Two Clarification Questions to WEC on the License Renewal

Westinghouse Response to Question 1:

Westinghouse Response to Question 2:

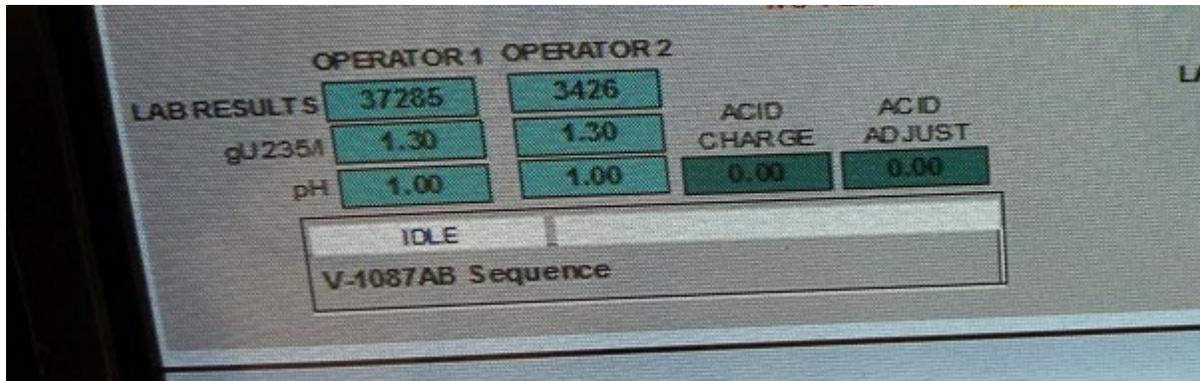
Discuss the technical basis for the administrative controls (AC) in AC pairs listed at the end of this question are independent to each other.

Additional information: The ISA Summary lists many cutsets having two ACs that are about the same task performed by different individuals. The descriptions of the ACs suggest that many of them have an individual (the first AC) performing the task and the second individual (the second AC) verifying the performance of the first individual. The ISA Summary shows that the two ACs have the same likelihood index. That suggests the two ACs are independent to each other. This raises a question about the effects of task dependency on the reliability of the second individual. The task performed by an individual and verified by another person is more appropriately modeled as an enhanced AC IROFS, instead of two AC IROFS. Depending on the task practices and other considerations, it may be appropriate to model them as two ACs and independent to each other. For example, if the two individuals perform the same task in duplications first, then compare their results afterward. This type of operation is appropriate to model as two independent ACs. This question focuses on human reliability. The non-human related considerations are assumed as designed. For example, if multiple samples are used, it is assumed that all samples, if measured correctly, all samples will result in the same decision. The measurement equipment is assumed function as designed. The list below shows examples of the AC pairs of the interest. The page numbers below are according to ISA Summary 2022.

ISAs are generated and maintained in accordance with Chapter 4 of our License Application, specifically in accordance with the “Integrated Safety Analysis Handbook” as described in section 4.1. According to CN-SB-18-001, “Baseline Integrated Safety Analysis (ISA) and ISA Summary Handbook,” The initiating event and mitigating events must be independent (i.e., no common features or coupling mechanisms exist between events that may cause multiple failures).” Each example that was identified is addressed below to show that the administrative actions specified by the controls that were questioned are independent per the ISA Handbook. Each control form discussed below has unique boxes for each inspection result and verifier’s signature. In addition, there is a management review of all forms filled out that document IROFS. The manager review signature is included on the control form. This management review was an administrative control reliability effort implemented after the S-1030 scrubber event. The latest SSC failure trending report (LTR-EHS-22-23) was also reviewed. Trends over a 5-year period are evaluated in this report. In the last five years there were no failures of any of the controls listed below.
